DOMINION ENERGY KEWAUNEE, INC.
KEWAUNEE POWER STATION
RESPONSE TO REQUEST FOR ADDITIONAL INFORMATION:
LICENSE AMENDMENT REQUEST 244, PROPOSED REVISION TO
RADIOLOGICAL ACCIDENT ANALYSIS AND CONTROL ROOM ENVELOPE
HABITABILITY TECHNICAL SPECIFICATIONS (TAC NO. ME7110)

**RESPONSE TO REQUEST FOR ADDITIONAL INFORMATION:
LICENSE AMENDMENT REQUEST 244, PROPOSED REVISION TO
RADIOLOGICAL ACCIDENT ANALYSIS AND CONTROL ROOM ENVELOPE
HABITABILITY TECHNICAL SPECIFICATIONS**

**NRC REQUEST FOR ADDITIONAL INFORMATION QUESTIONS AND DOMINION
ENERGY KEWAUNEE RESPONSES**

**KEWAUNEE POWER STATION
DOMINION ENERGY KEWAUNEE, INC.**

E-2003

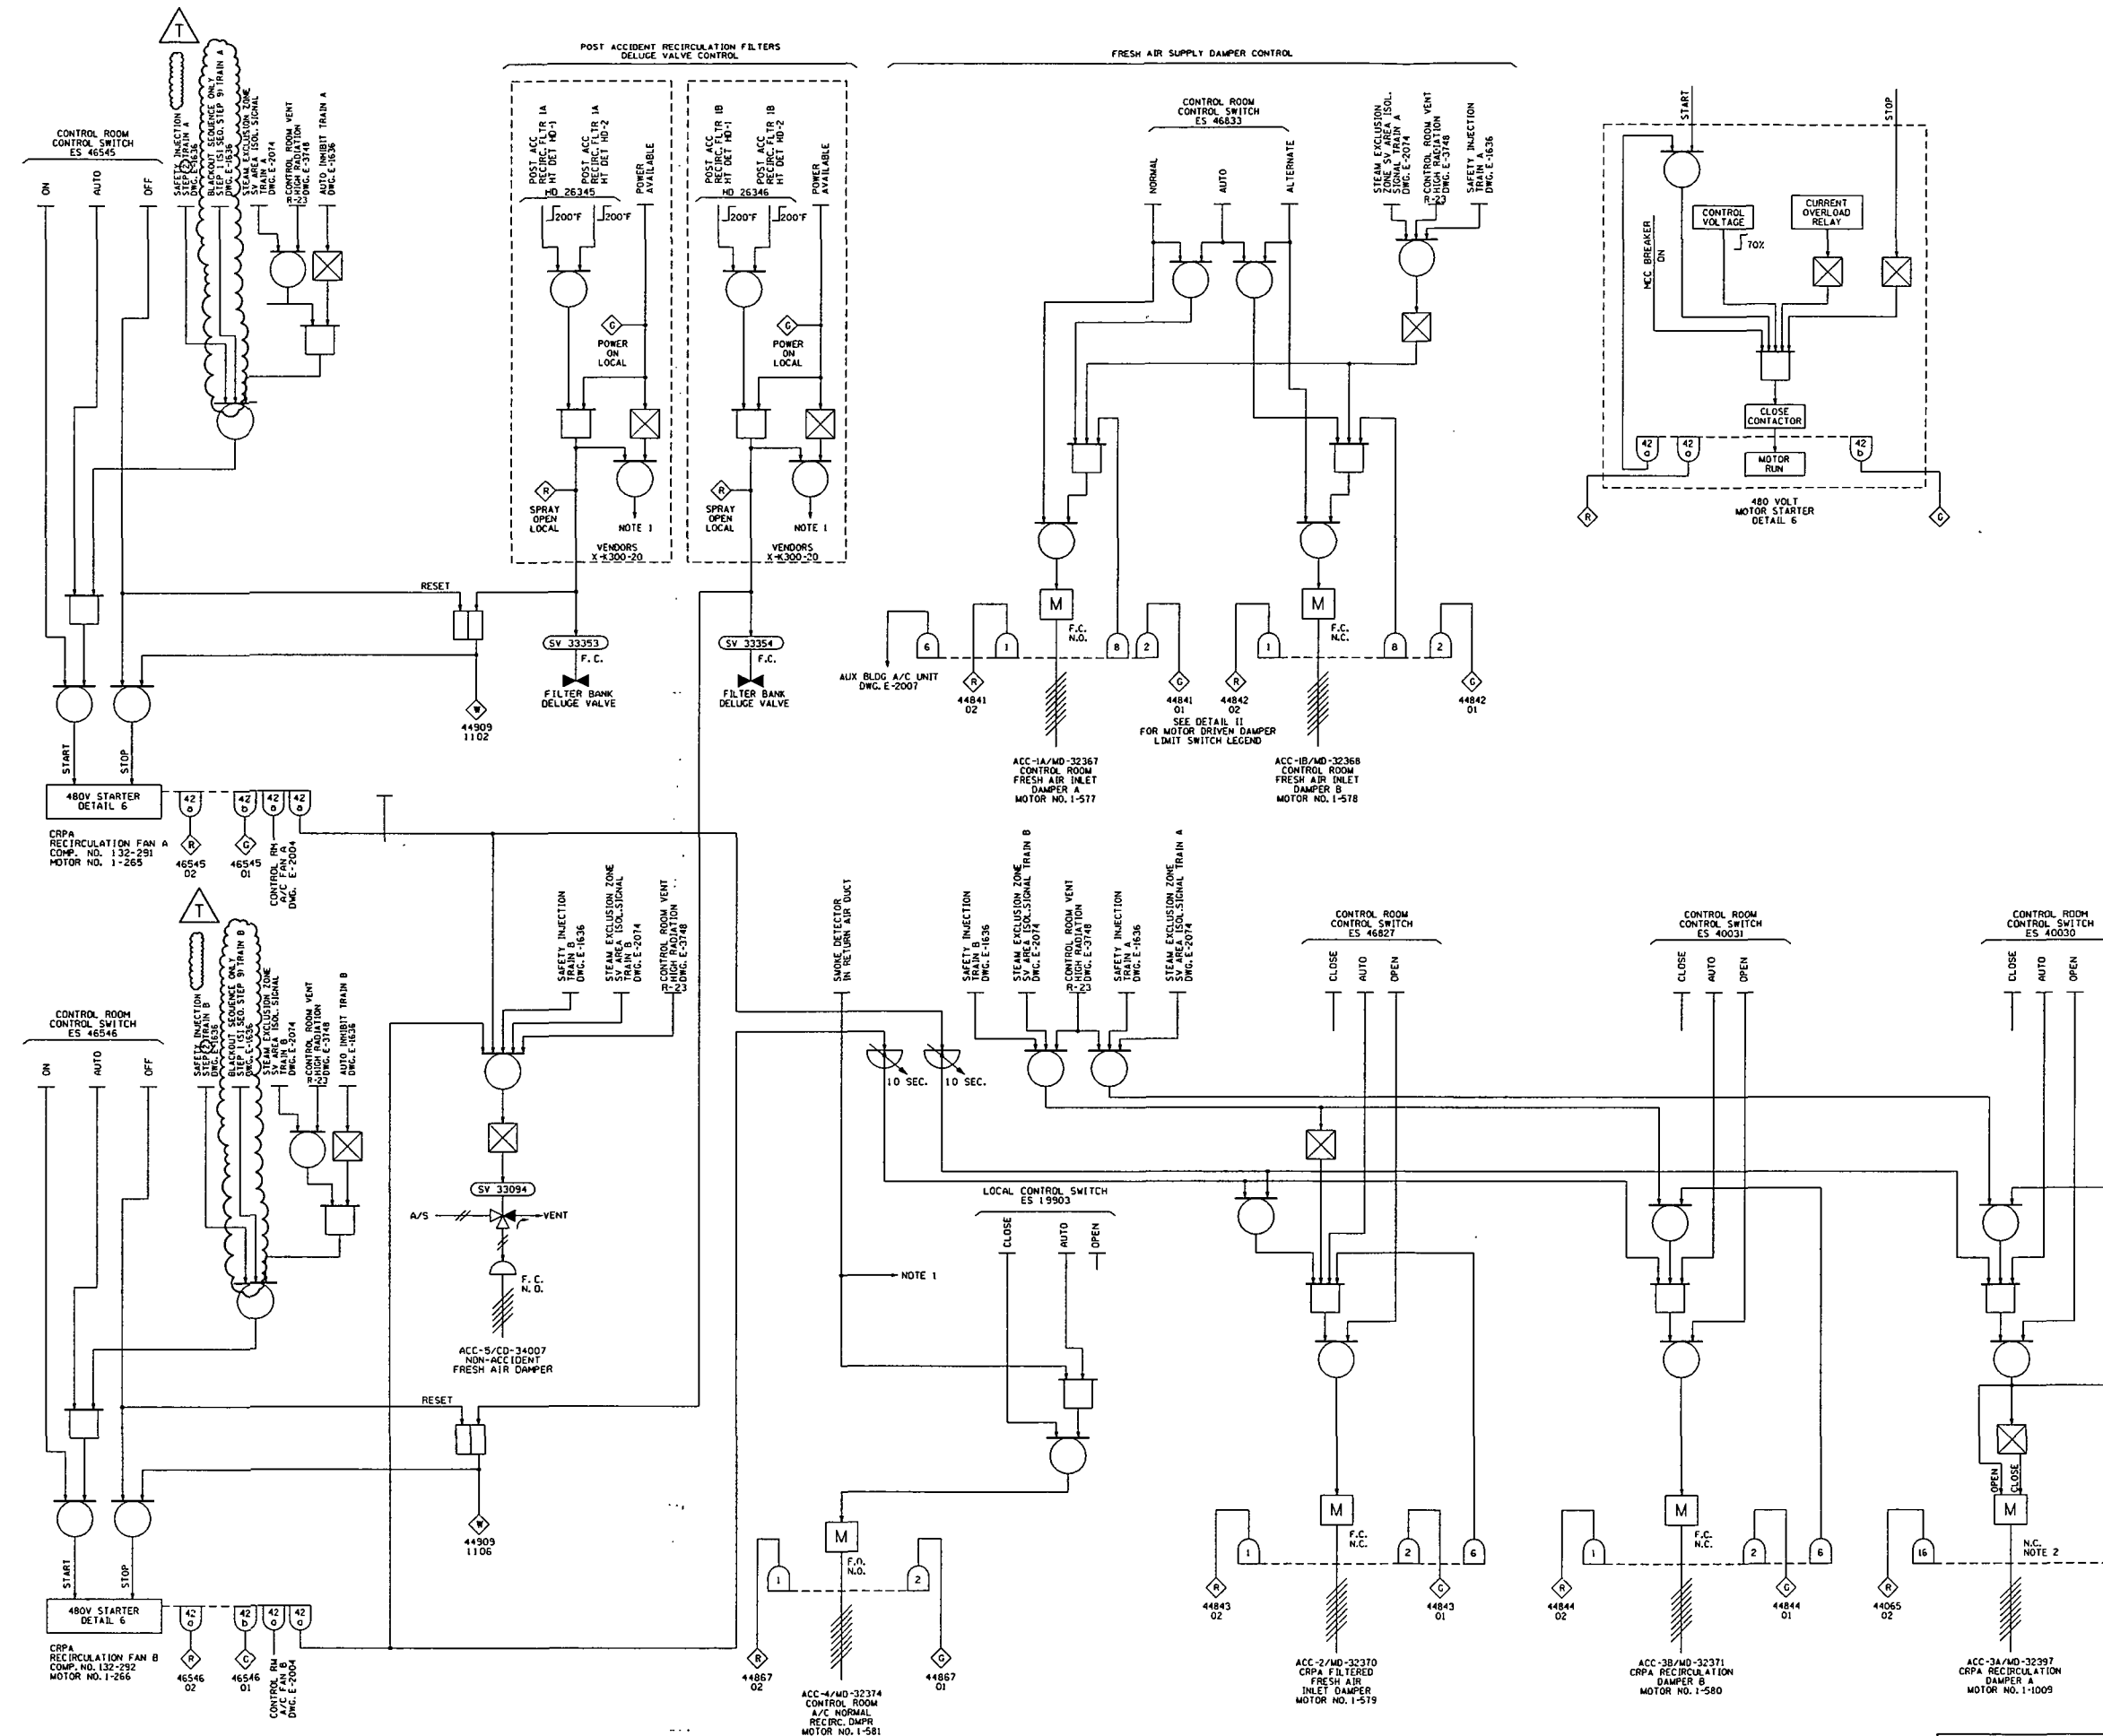
"LAR-244, Attachment 4, Section 2.7, 3.3.1, and 3.6.1, state that full control room isolation require action by the operator to close monitor dampers that are not included in the isolation logic (of the control room ventilation radiation monitor). This was not discussed in previous LARs or in FSARs. Please explain the following:

- a. Where is this information described? Provide a logic diagram and a description for operation of all dampers required for the control room ventilation radiation system.*
- b. Are these monitor dampers closed by the SI signal? If not, what signal actuates them?"*

The revised FHA requires that the control room be isolated prior to moving recently irradiated fuel. This requirement has been proposed as a new TS 3.7.10 requirement. The revised FHA also requires that the CRPAR is started by manual operator action within 20 minutes of the release. This is accomplished by placing the control switch to ON to start the respective fan. The proposed manual action is simple, can be accomplished from the control room, and will be procedurally controlled. The manual start of CRPAR is shown on the CR ventilation logic diagram (see Logic Diagram E-2003 in Enclosure 1).

CR isolation and CRPAR start is shown on Logic Diagram E-2003 (see Enclosure 1).

- a. Actuation of the control room ventilation radiation monitor (R-23) is described in logic diagram E-2003, "Integrated Logic Diagram - Control Room A/C System." A copy of this logic diagram is included in Enclosure 1 of this letter. A description of the system response to an R-23 actuation is as follows:
 - Post-Accident Recirculation Fans A and B start.
 - A/C Fans A and B start if in **ON** or **AUTO**.
 - Motor Operated Dampers ACC-1A/MD-32367 and ACC-1B/MD-32368 close to isolate both control room fresh air intakes.
 - Solenoid Valve SV-33094 de-energizes and closes the Non-Accident Fresh Air Damper ACC-5/CD-34007.
 - Post-Accident Recirculation Dampers ACC-3A/MD-32397 and ACC-3B/MD-32371 open.
 - Normally closed Post-Accident Fresh Air Damper ACC-2/MD-32370 closes if open.

The following dampers must be closed to achieve full isolation of the control room boundary and are not isolated by an R-23 actuation signal. These dampers must be manually closed after an R-23 actuation signal unless the R-23 signal is accompanied by an SI signal.

- Close Recirculation Relief to Turbine Room Dampers ACC-20/CD-34061 and ACC-21/CD-34602.
- Close Kitchenette/Toilet Exhaust Dampers ACC-10/CD-34064 and ACC-11/CD-34063.

- b. Manual or automatic actuation of SI produces the same system response as an actuation of R-23 and also isolates the dampers listed above that are not isolated by an R-23 signal. The following automatic actions occur upon receipt of a SI signal/sequence.

- Post-Accident Recirculation Fans A and B start.
- A/C Fans A and B start if in **ON** or **AUTO**.
- Motor operated Dampers ACC-1A/MD-32367 and ACC-1B/MD-32368 close to isolate both fresh air intakes.
- Solenoid Valve SV-33094 de-energizes and closes the Non-Accident Fresh Air Damper ACC-5/CD-34007.
- Post-Accident Recirculation Dampers ACC-3A/MD-32397 and ACC-3B/MD-32371 open.
- Normally closed Post-Accident Fresh Air Damper ACC-2/MD-32370 closes if open.
- Recirculation relief to Turbine Room Dampers ACC-20/CD-34061 and ACC-21/CD-34602 close.
- Kitchenette/Toilet Exhaust Dampers ACC-10/CD-34064 and ACC-11/ CD-34063 close.
